Davidson Drive Holdings, LLC  
Town of Chester, Orange County, New York  
Colliers Engineering & Design Project No. 23002650A

As requested, Colliers Engineering & Design (CED) has completed a review of the revised Site Plans prepared by Arden Consulting Engineers, PLLC revision dated February 6, 2023 and revised Traffic Impact Study prepared by Creighton Manning Engineering, LLP (CM) dated September 21, 2021 and revised February 15, 2023 (Revision #2) submission for the proposed Davidson Drive Holdings, LLC development as well as the CM letter dated February 15, 2023, which provides responses to specific comments contained in our January 30, 2023 review letter. Below we have provided those items which we consider outstanding or requiring additional review by the Planning Board, all other items from our previous letter have been fully addressed by the resubmission.

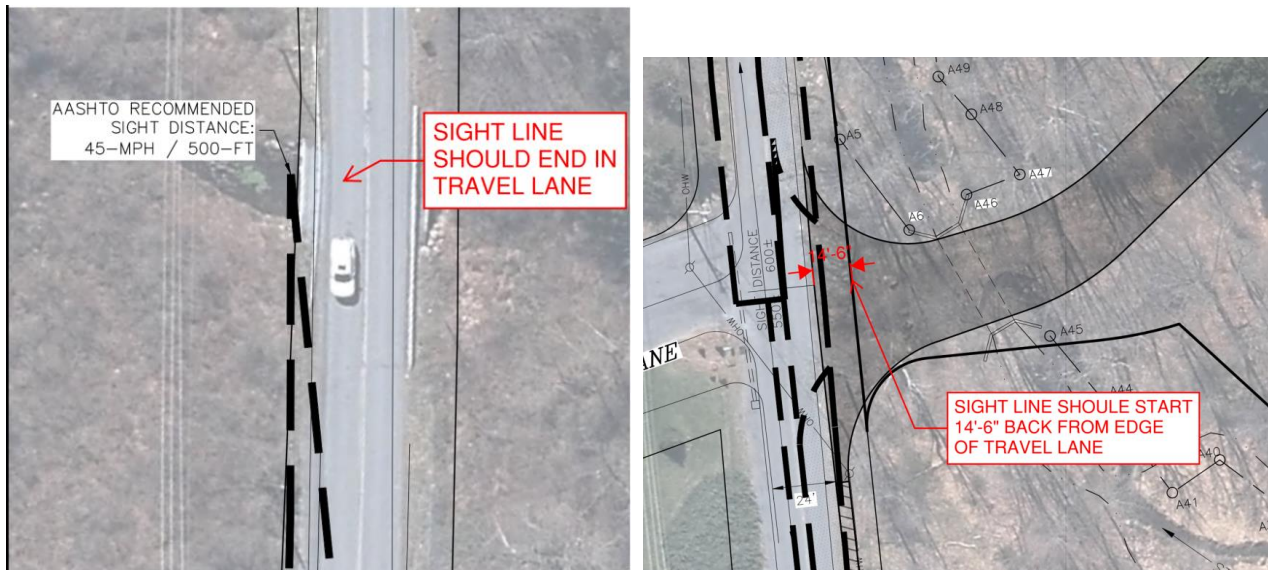
16. CED Previous Comment: It is unclear how the intersection of NYS Rout 17M/Lehigh Avenue/Kings Highway was conducted. Based on the analysis reports it appears that this intersection was analyzed as two separate intersections rather than a clustered intersection as would be anticipated for this location. However, the Level of Service Summary Table does indicate the fact that this is a clustered intersection. This should be clarified. It would be beneficial for the Synchro analysis files to be provided to our office for review of this item.

*CM Response: The intersection was modeled as a clustered intersection. Each intersection was analyzed using HCM methodology, with the results listed in Table 3 of the revised TIS. The synchro files will be provided via zip file in an email directly to Mr. Richard D'Andrea of Colliers.*

**Colliers: Will be reviewed upon receiving latest Synchro files.**
